C2  
1**ZONING CHANGE REVIEW SHEET****CASE:** C14-2012-0086  
Lost Creek**ZAP DATE:** September 4, 2012**ADDRESS:** 1142 Lost Creek Boulevard**AREA:** 1.447 acres  
(63,031 square feet)**OWNER:** Stern Trust  
(Robert P. Stern)**AGENT:** LOC Consultants  
(Sergio Lozano)**ZONING FROM:** LO; Limited Office**ZONING TO:** MF-1; Multifamily Residence Limited Density**NEIGHBORHOOD PLAN AREA:** N/A**SUMMARY STAFF RECOMMENDATION:**

The staff recommendation is to grant multifamily residence limited density – conditional overlay (MF-1-CO) district zoning. The conditional overlay would limit the number of units to 15 and requires that all compatibility standards, as listed in the Land Development Code, Chapter 25-2, Article 10 (Compatibility Standards), apply.

Figure 1. Traffic Counts

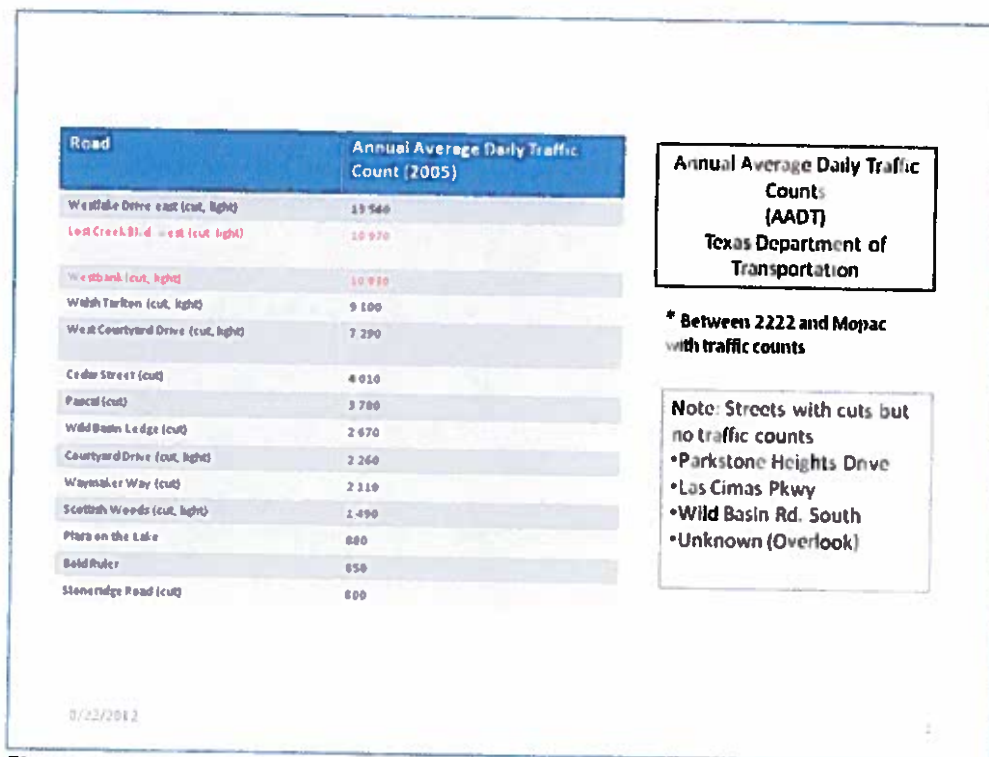
1. **Unsafe Entrance/Exit from Property** When approval was given (about 30 years ago) to allow a drive-thru bank on the land, the neighborhood approved, based on certain usage intent, entrance and exit restrictions. We were told that the drive through bank was for the convenience of the residents of Lost Creek. Since the traffic is high on Lost Creek Blvd. (Figure 1), there is a blind curve to the left of the edge of the property (Figure 2), and single lane on Lost Creek Blvd., the exit from the drive-thru bank was a merge entry to the right with no option for a left turn (Figure 3). The current entrance to the property is via a road at the far end of the property (not shown on all the drawings provided by the developer). It was supposed to be an entrance only, but is now two way. Cars exiting on this road can make a right turn safely, but a left turn is dangerous because of a blind hill (Figure 4). Cars can go through the office park and find their way back to Loop 360 for a safe right turn to go South, followed by a u-turn at Lost Creek Blvd. to go North (Figure 5). However, these roads are part of other developments in the office park and not under the control of the City or the developer of the proposed condominium project.

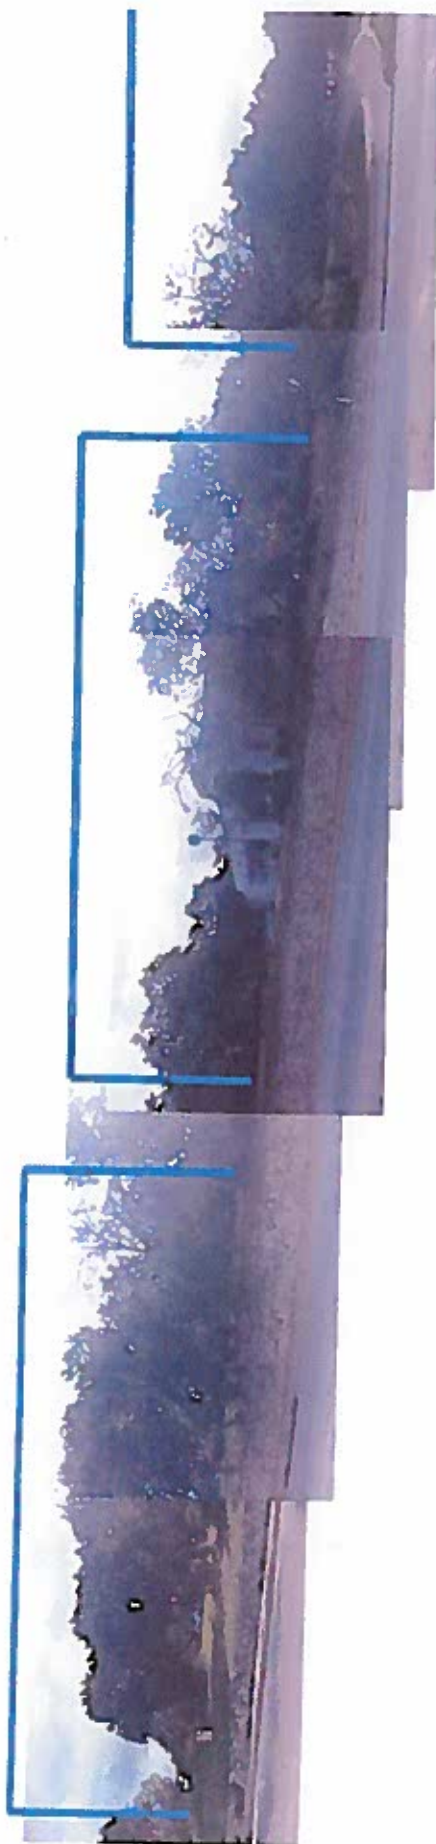
3. **Poor Curb Appeal** The current drive-thru bank is hardly visible on entering Lost Creek (Figure 6) and pretty well hidden by trees on a more direct view (Figure 7). However, three, three story buildings packed tightly into the property with only a 25 foot setback will not be appealing. (Figure 8) There are two houses (Figures 9 and 10) directly opposite 1142 Lost Creek Blvd. that will have to look at these buildings uphill from them and have the residents on balconies looking down on them.
